**CITY OF VANCOUVER**  
**DEVELOPMENT, BUILDINGS, & LICENSING**

**DEVELOPMENT PERMIT STAFF COMMITTEE**  
**MEETING**  
**April 14, 2021**

**3701 West Broadway (COMPLETE APPLICATION)**  
**DP-2020-00888**

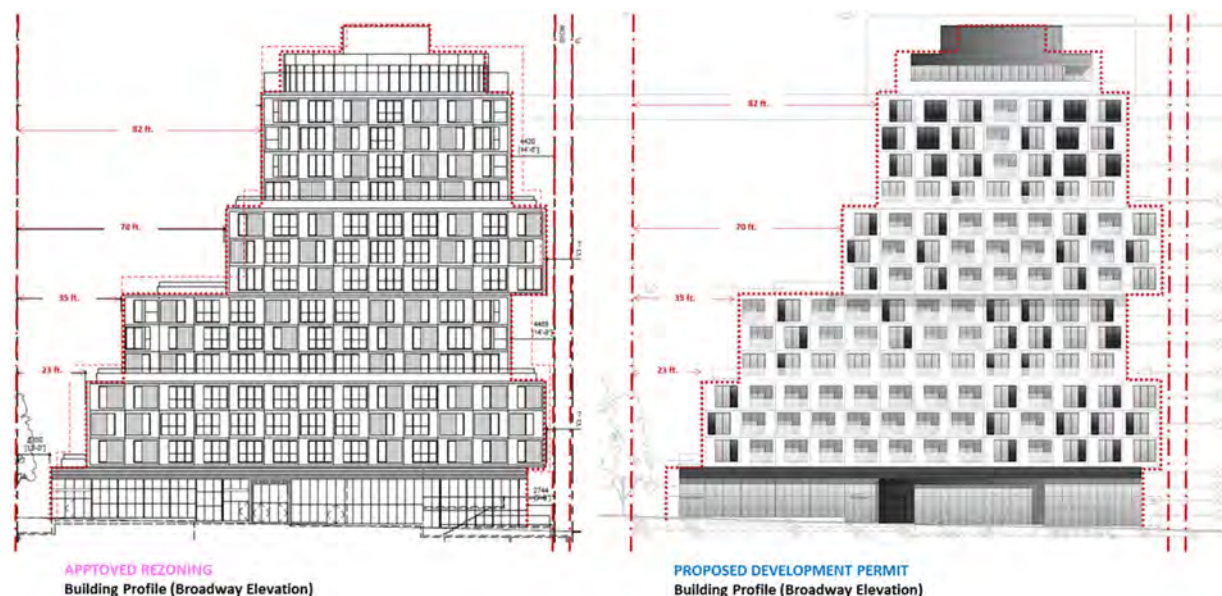
- 1.2 design development to reduce the negative impacts of the cantilevered overhang between Level 07 and Level 08;

**Note to Applicant:** This can be achieved by shifting the floor plates on Levels 05, 06 and 07 by approximately six feet (6'-0") to the South and East. Whereas the setbacks on the South and East are reduced for these floors, the setbacks on the North and West should be increased commensurately from approximately 35 ft. to approximately 41 ft. The intent of this condition is to improve liveability on affected units on levels 05, 06 and 07 by allowing them better access to daylight and views. Additionally, this shift may help reduce the impact of a top-heavy appearance of bulk and massing at the upper levels may have on the surrounding context.

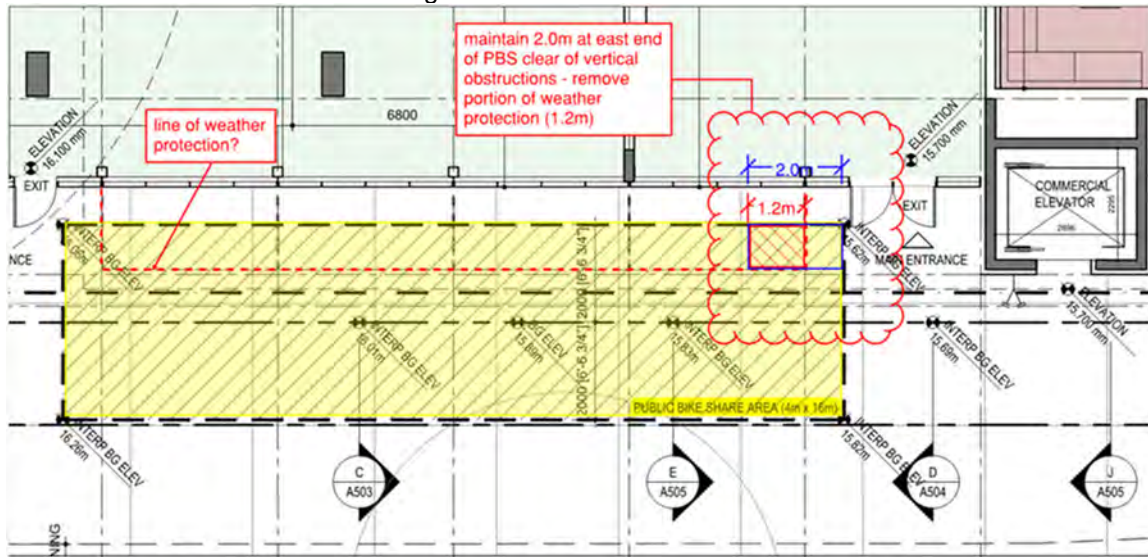
A.2.13 the size and location of the PBS space as shown on Drawing A301/L1.11 is acceptable provided it meets the following requirements for sun exposure and power;

- a. update drawings A503 and L3.03 to clearly label and dimension the height of the proposed weather protection (glass awning) above the PBS space along the W Broadway frontage.

**Note to Applicant:** This is required to confirm that 5m vertical clearance is provided above the PBS space. There must be a minimum of 5m vertical clearance in order to maximize sun exposure as station operates on solar power. Ideally the station should receive 5 hours of direct sunlight a day.

- b. remove a portion of the proposed weather protection at the east end of the PBS SRW.
